SUBDIVISION, PLANNED UNIT DEVELOPMENT, &

PLANNING APPROVAL STAFF REPORT Date: November 2, 2006

DEVELOPMENT NAME Ashland Place United Methodist Church

SUBDIVISION NAME Ashland Place United Methodist Church Subdivision

SITE PLAN

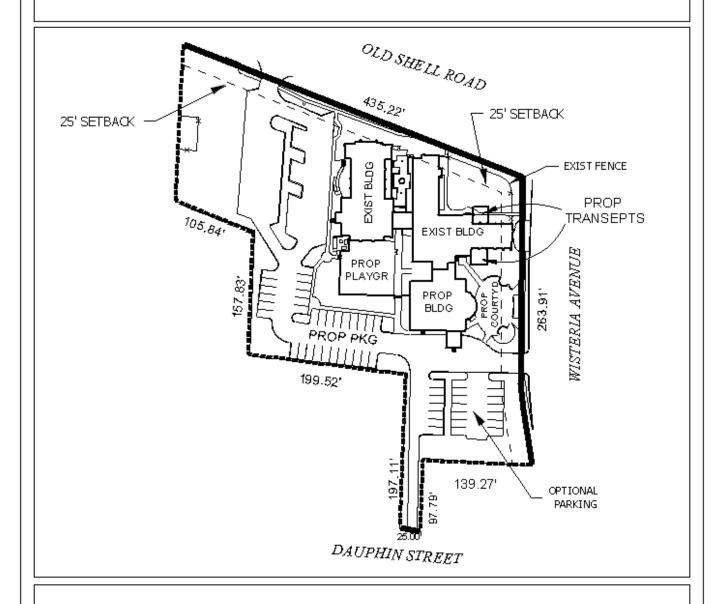
The site plan does not illustrate a parcel that is shown on the subdivision plat, a metes and bounds parcel containing a single family home to the West of the site; the applicant's architect states this is currently used for administrative purposes, but would not be needed as such following construction of the administrative building. This site should either be brought into the present PUD and Planning

Regarding circulation on the site, most aspects would meet the requirements of the Zoning Ordinance. However, the site has a 25-foot access to Dauphin Street, which could not accommodate two-way traffic. Neighboring property owners have stated that this is a desirable alternative to Wisteria Avenue for access, but the parking area must be signed and marked to restrict it to one-way traffic.

While the nature of the proposed building improvements would appear harmonious with the surrounding development, there are some concerns about replacement of viable single-family homes with parking for the church. As Wisteria Avenue is a small street, each house weighs heavily in the balance of its residential character. There are currently only five homes on the East side of Wisteria Avenue, and the last two of their complements on the West side of Wisteria Avenue are proposed for demolition. That this would occur to provide parking that is not even required by the Zoning Ordinance makes it inadvisable. There is undeveloped land to the West of the existing parking area facing Old Shell Road, the development of which would have less of an impact on residences across Old Shell Road, because they face the side streets rather than the church property. It is worth noting that the interior of the block bounded by Old Shell Road, Wisteria Avenue, Dauphin Street, and Homer Street has an abundance of undeveloped property that might be acquired and subdivided to provide the church with future parking that would not undermine the residential character of the neighborhood. Prior to demolishing existing residential structures, the church should demonstrate that more "harmonious" options for parking development have been exhausted.

Due to these concerns, it is recommended that the site plan and subdivision be revised to incorporate all areas to be redeveloped, and ideally to eliminate the residential sites on Wisteria Avenue from the site plan and subdivision plat.

Planned Unit Development Based on the preceding, it is recommended that the application be held over to the December 7th meeting, to allow the applicant to submit revised plans illustrating the entire area to be redeveloped. Revisions should be received by November 15th to be considered.
